SALES ASSEMBLY HDM BACKPLANE MODULE OPEN END OPTION

PRODUCT CUSTOMER DRAWING

DOCUMENT NUMBER: SDA-73642-XXXX | DOC TYPE: PSD | DOC PART: 001 | REVISION: K

DRAFT WHERE APPLICABLE MUST REMAIN WITHIN DIMENSIONS | THIRD ANGLE PROJECTION | DRAWING: B-SIZE | SERIES: 73642 | MATERIAL NUMBER: SEE CHART | CUSTOMER: GENERAL MARKET | SHEET NUMBER: 1 OF 2

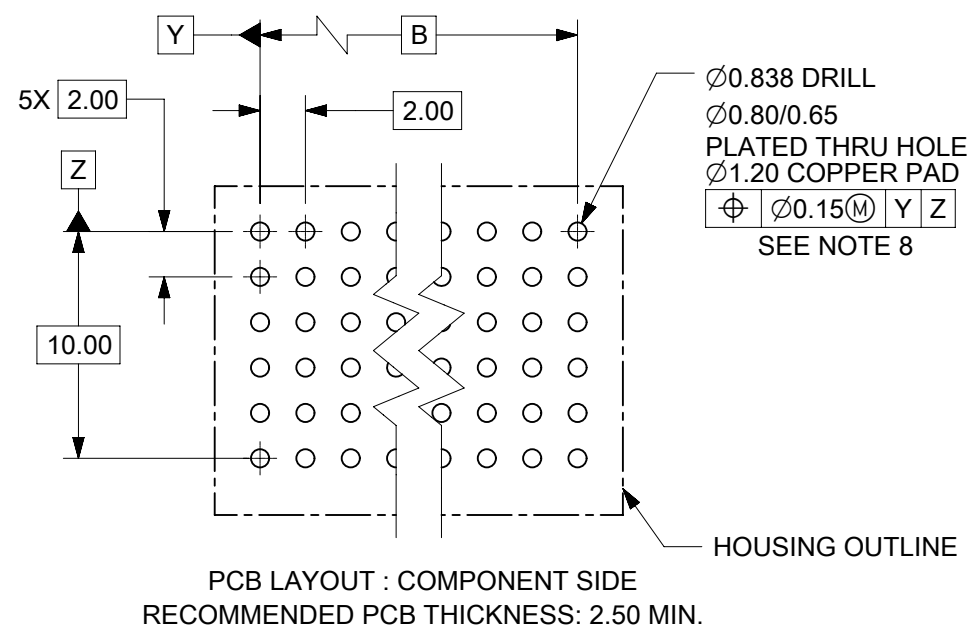
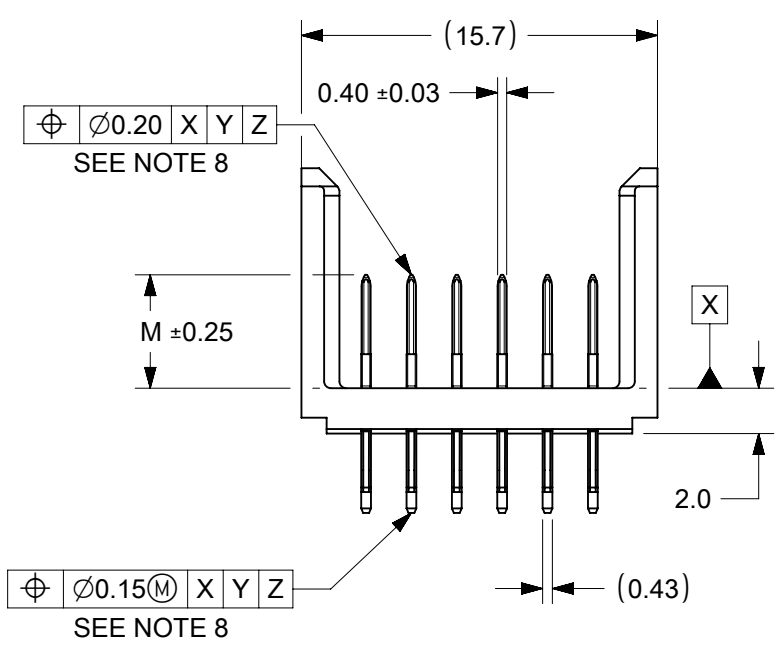
DATE	REVERSION	DESCRIPTION
2021/11/12	K	1. DRAWING MIGRATION. 2. PART NUMBER CHART MOVED TO SHEET 1 FROM SHEET 2, TO AVOID EXTRA SHEETS. 3. SHEET 1: E09: DIMENSION 0.92 REMOVED BECAUSE DIM 'A' AND DIM 'B' ARE WITH SAME CENTER LINE, SO DIM 0.92 IS NOT REQUIRED. 4. SHEET 1: D05: DIM 0.42 CHANGED TO 0.40±0.03MM, TO FOLLOW ACTUAL COMPONENT DIMENSION. 0.39 5. SHEET 1: D08: TOLERANCE OF DIM 'A' CHANGED TO ±0.15 FROM ±0.10, TO FOLLOW ACTUAL COMPONENT DIMENSION. 6. SHEET 1: C04: DIM 2.00 CHANGED TO DIM 2.0 TO INCREASE THE TOLERANCE TO FOLLOW ACTUAL COMPONENT DIMENSION. 7. SHEET 1: E04: ADDED NOTE 8 FOR POSITION TOLERANCE MEASUREMENT. 8. SHEET 1: C04, D03, E10, F08 : REMOVED BRACKET FROM THE BASIC DIMENSION 10.00 , B , 10.00 , B RESPECTIVELY FOR TP CONTROL 9. SHEET 1: D06, B06, C01 : ADDED "SEE NOTE 8" FOR TP CONTROL 10. SHEET 1: REMOVED "-" AND "*" SYMBOLS FROM ALL THE PART NUMBER AND MATERIAL NUMBER, TO MAINTAIN NEW STANDARD.
